# UNITED STATES PATENT AND TRADEMARK OFFICE

APPLICATION NO.	FILING DATE	FIRST NAMED INVENTOR	ATTORNEY DOCKET NO.	CONFIRMATION NO.
09/550,649	04/17/2000	Jarod Guertin	CNA-029	1375
2292	7590	12/13/2005	EXAMINER	
BIRCH STEWART KOLASCH & BIRCH PO BOX 747 FALLS CHURCH, VA 22040-0747			KIM, DAVID S	
			ART UNIT	PAPER NUMBER
			2633

# Office Action Summary

FIG. 2

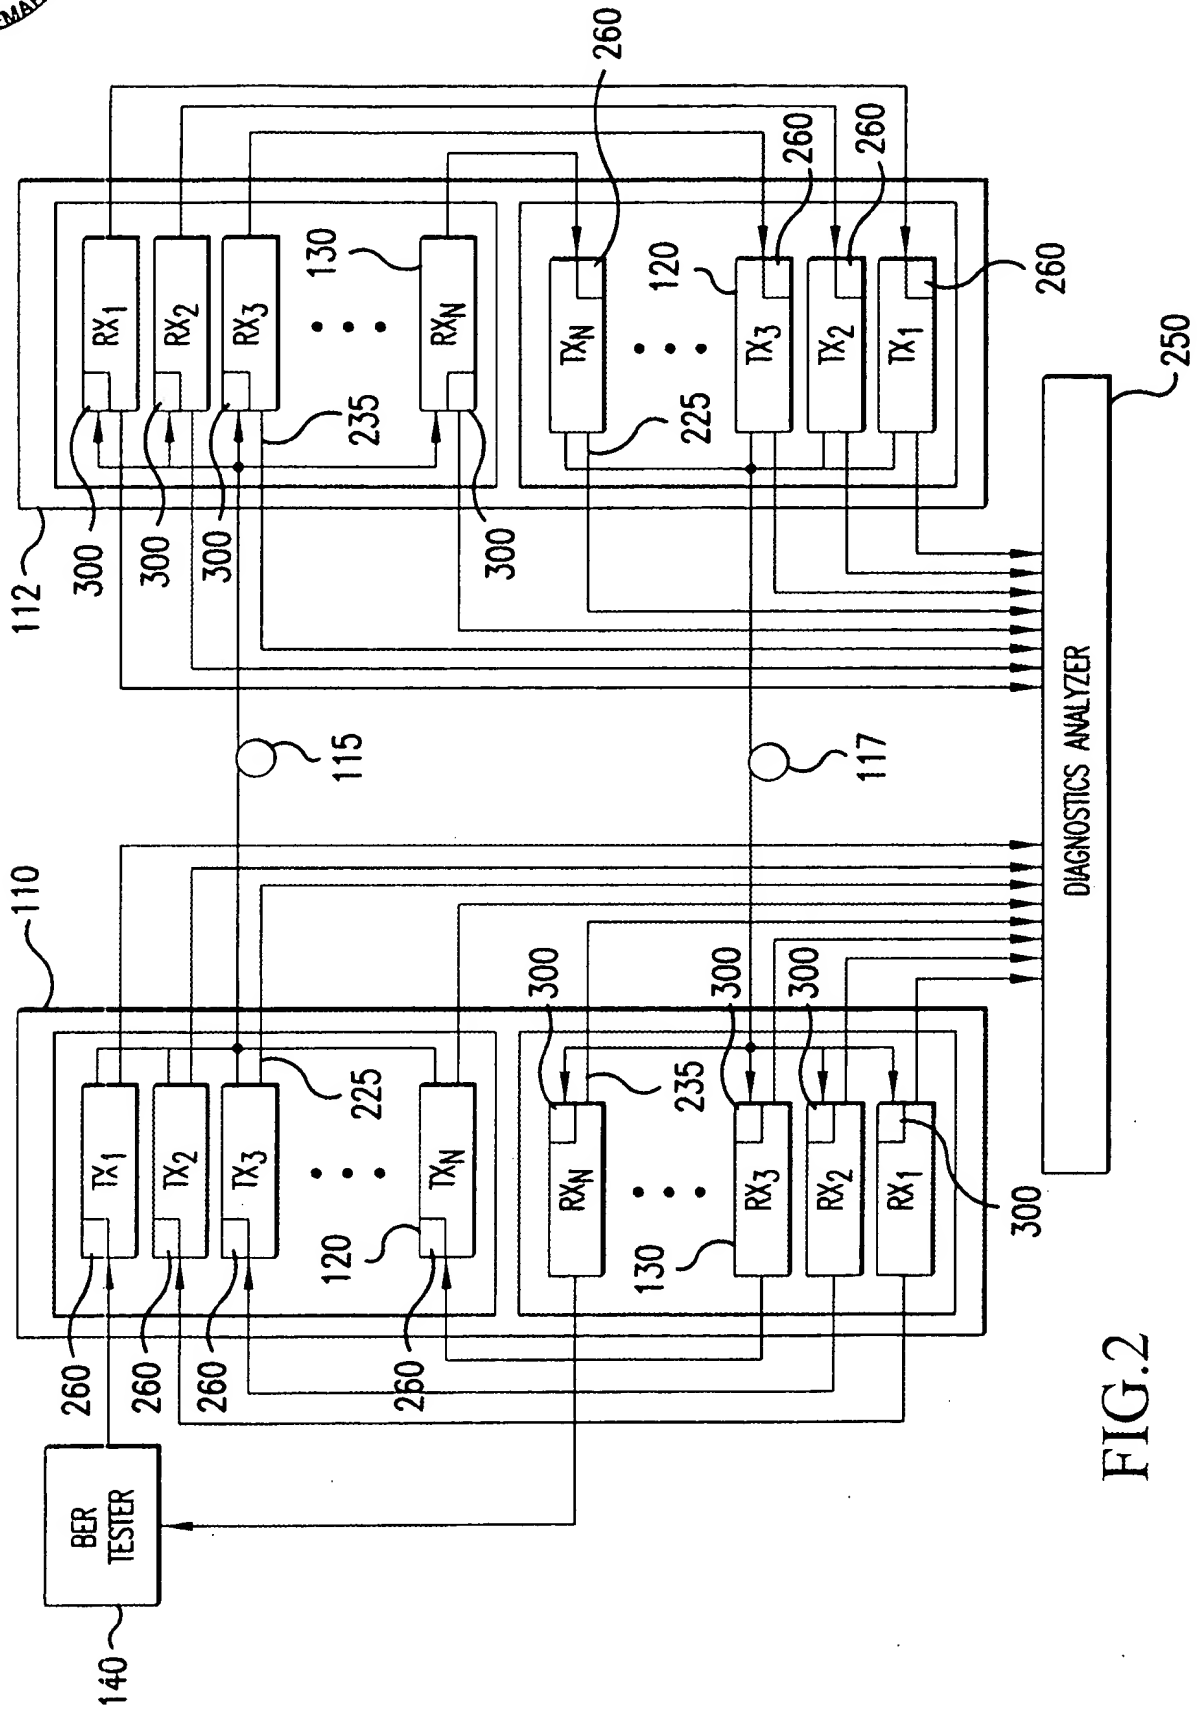
1. Applicant's compliance with the objections to the drawings in the previous Office Action (mailed on 14 March 2005) is noted and appreciated. Applicant's responded by filing a replacement drawing sheet for Fig. 2 on 13 June 2005. This drawing is disapproved. The location of the box for reference character 300 of  $RX_N$  of element 112 is in the wrong location. That is, for consistency with the other  $RX$  units of element 112, this box should be located in the upper left corner of  $RX_N$ , not the lower left corner. For example, the version shown in the Annotated Sheet of Fig. 2, also filed on 13 June 2005, correctly shows the location of this box in the upper left corner.

Disapproved by  
Dsk
